Proposed Final Amendment

1996 Remsen-Lake Placid Travel Corridor Unit Management Plan

Final Supplemental Environmental Impact Statement

Review of Rails-With-Trail Design Proposal by Trail with Rail Action Committee (TRAC)

TRAIL SECTION: McCauley Pond

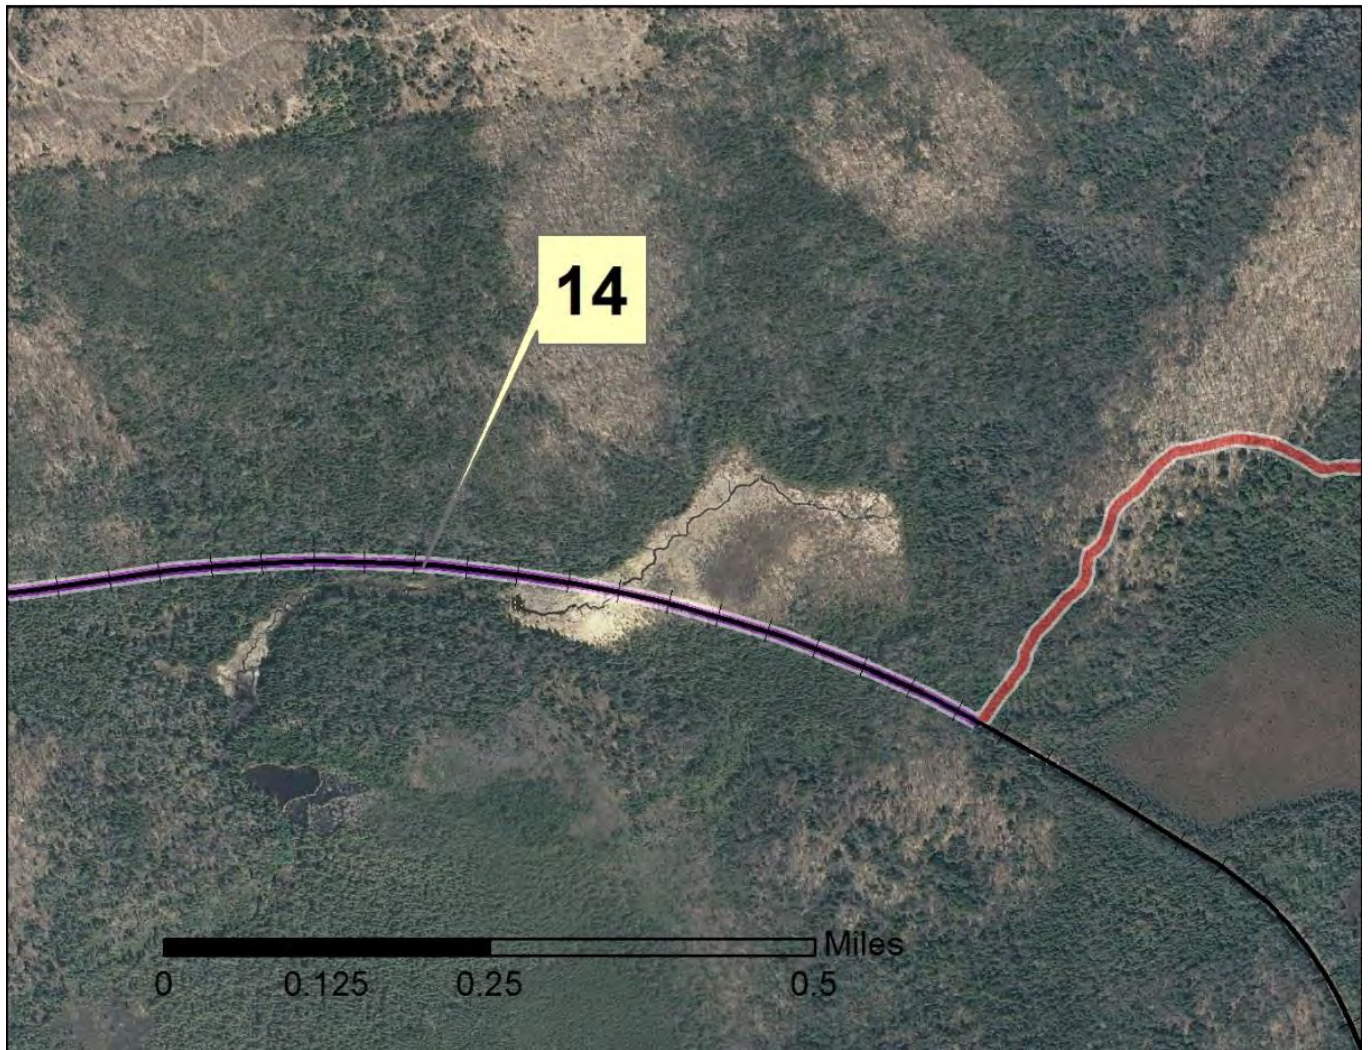
Map Point #13 shows where TRAC proposes a segment approximately 1 mile “Along Corridor”, which would result in adverse impact or loss of regulated wetlands.

Map Point #14 shows where TRAC proposes a segment approximately 0.7 mile “Along Corridor”, which would result in adverse impact or loss of regulated wetlands.

TRAIL SECTION: Lake Colby/Saranac Lake

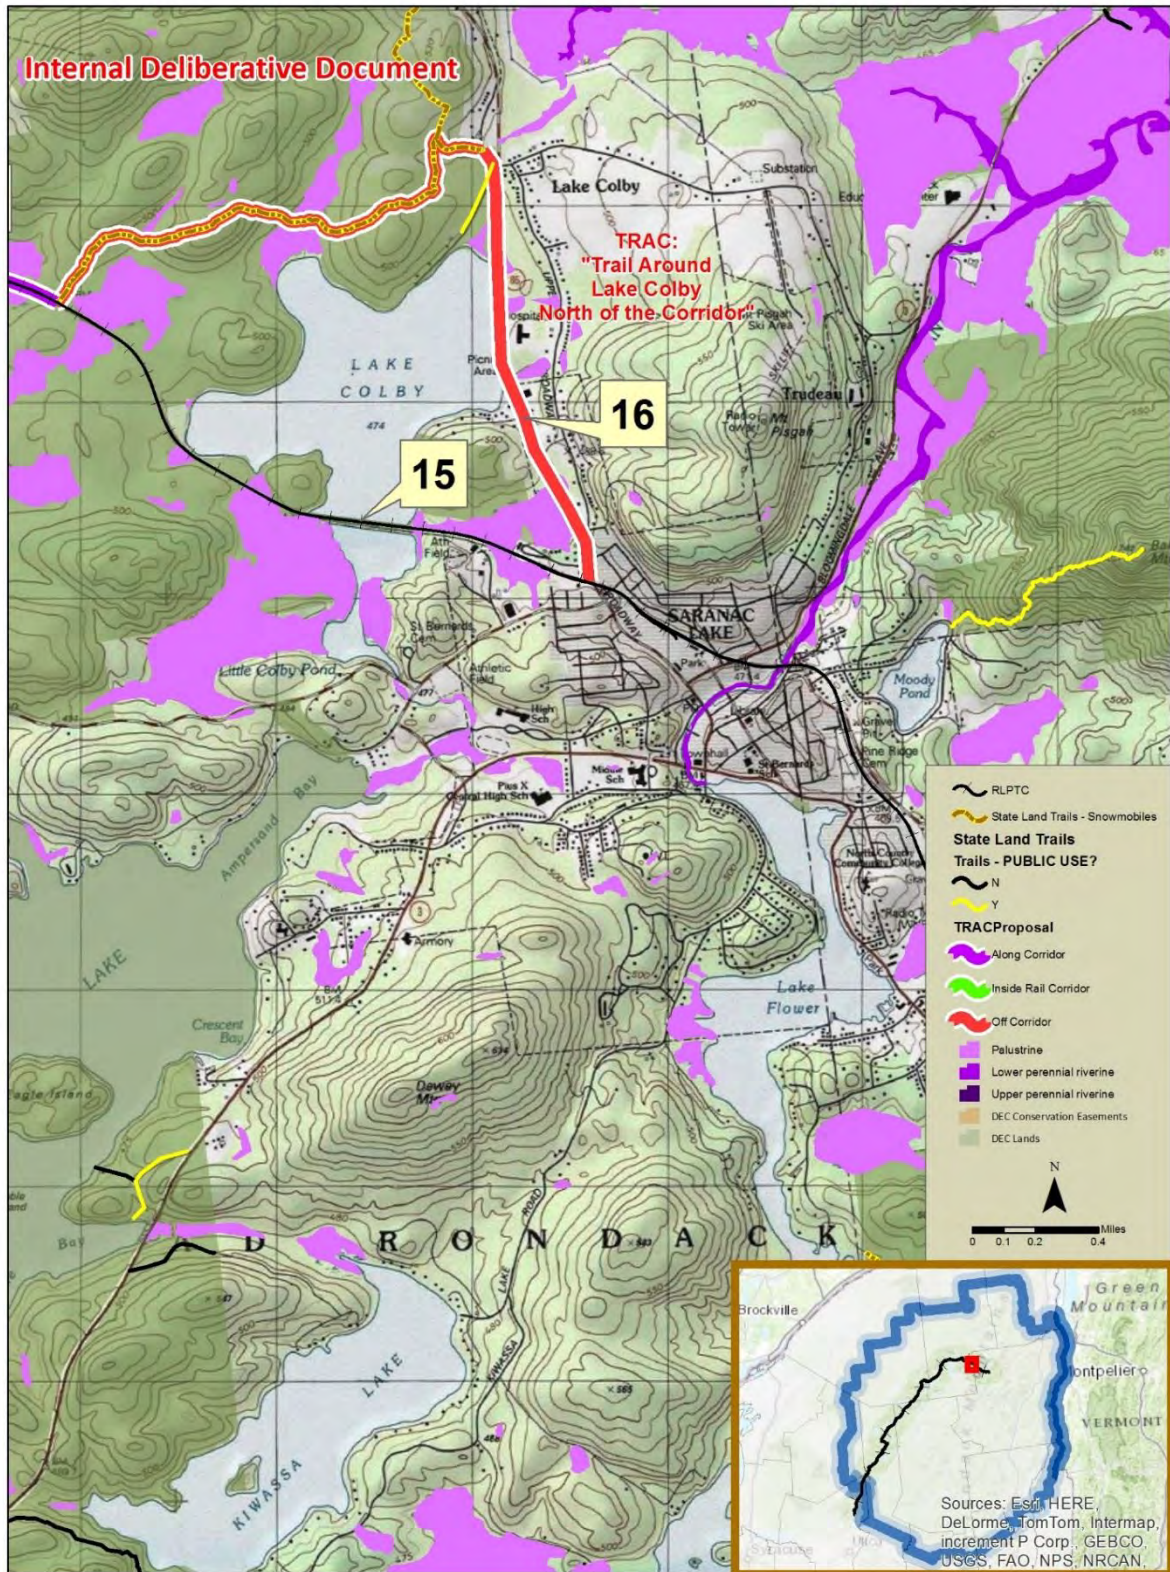
TRAC's route around Lake Colby bypasses the Lake Colby causeway (**Map Point #15**), which has potential to become fishing and paddling access for people with disabilities.
